A d d e n d u m

Iowa Department of Transportation
Office of Contracts

B.O.	Proposal ID	Proposal Work Type	County	Project Number	Addendum
110	78-0801-459	PCC PAVEMENT - GRADE & NEW	POTTAWATTAMIE	IM-NHS-080-1(371)3--03-78 IM-NHS-080-1(384)4--03-78 IM-NHS-080-1(459)3--03-78 IM-NHS-080-1(460)3--03-78 IM-NHS-080-1(461)3--03-78 NHSN-192-1(24)--2R-78 NHSN-192-1(25)--2R-78	19APR110.A01

Replace plan sheets C.7, Q.19, Q22, & W.55-W.62 for project IM-NHS-080-1(459)3--03-78 with the attached:

STAGE CONSTRUCTION NOTES:

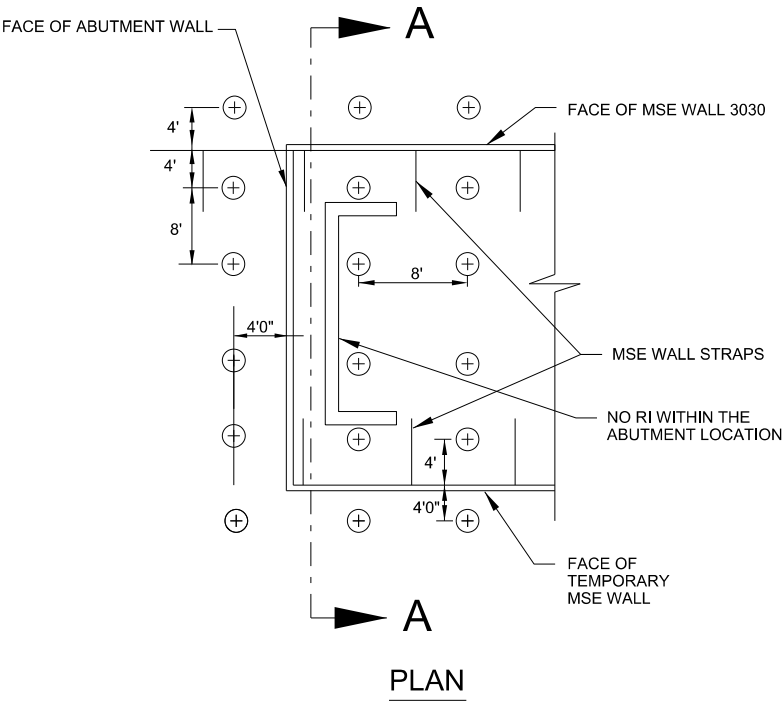
Table 1 : Required Holding Period for the Different Grading Areas				
Road	Station		Overbuild to Finished Grade	Required Holding Period (days) ¹
	From	To		
I-80 WB	7547+00	7549+00	Yes	30
	7555+25	7559+00	No	30
I-29 NB	8547+00	8548+00	No	30
	8548+00	8549+25	No	30
	8554+75	8559+50	No	30
Detour 300800	300833+50	300838+50	No	150

1. All the embankment within the areas summarized in Table 1 shall have a holding period after the end of grading. The required holding period are shown in Table 1.
2. The remainder of the fill embankment shall be constructed with no holding period.
3. The holding period in Table 1 is estimated and may change during construction. The Engineer will evaluate the settlement rate and confirms that the primary consolidation or elastic settlement is complete and the rate of settlement has stabilized.

DETAILS FOR RIGID INCLUSIONS

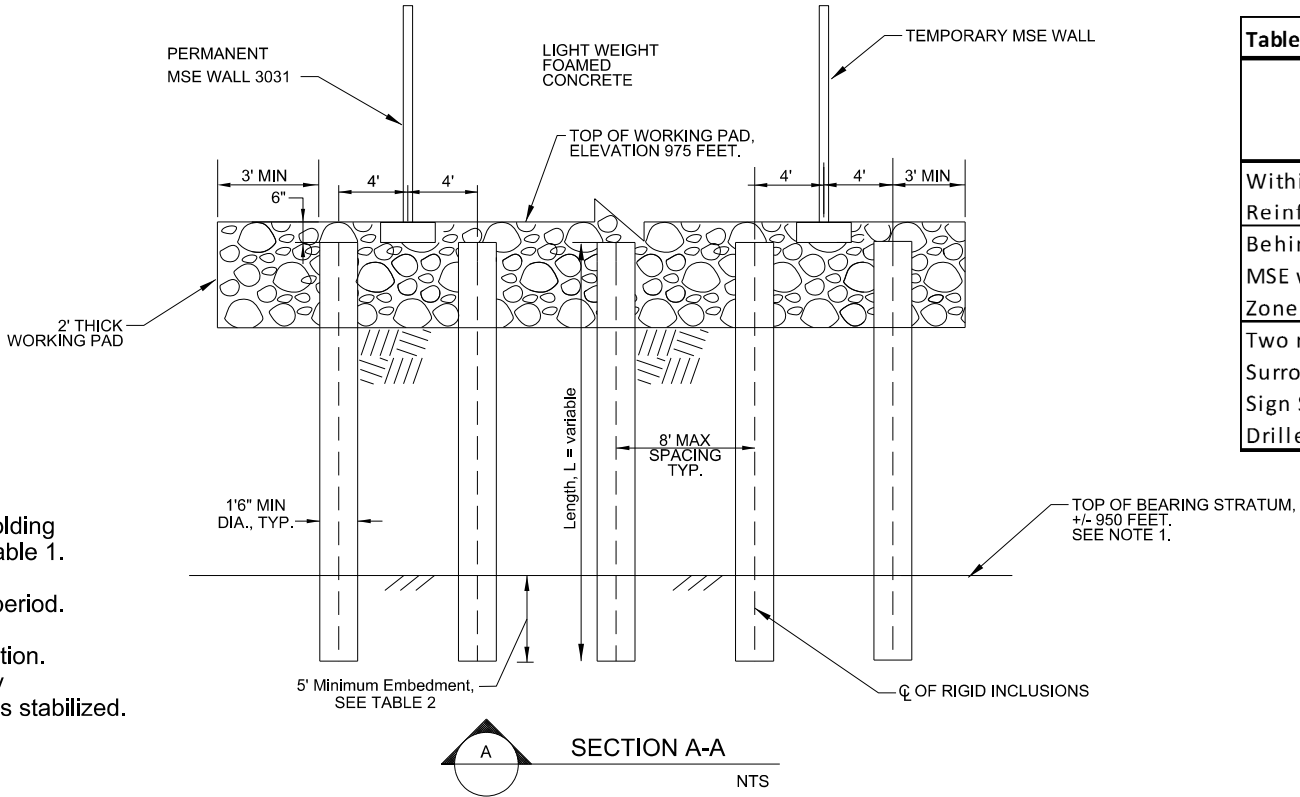
- NOTES:
1. THE TOP OF BEARING STRATUM IS APPROXIMATE AND WILL BE CONFIRMED IN THE FIELD DURING THE INSTALLATION OF PRE-PRODUCTION RI
2. INSTALLATION CRITERIA AND FINAL EMBEDMENT FOR RIGID INCLUSIONS SHALL BE ESTABLISHED BY IOWA DOT BASED ON INSTALLATION AND RESULTS OF LOAD TESTS ON TEST ELEMENTS
3. THE DESIGN SERVICE LOAD ARE PROVIDED IN TABLE 2.

Table 2: Design Load and Embedment for Rigid Inclusions			
Location	Design Axial Load (Kips)	Design Embedment (ft)	Estimated Tip Elevation (feet)
Within MSE wall Reinforced Zone	135	7	943
Behind and Front of MSE wall Reinforced Zone	120	5	945
Two rows Surrounding the Sign Structure Drilled Shafts	150	10	940
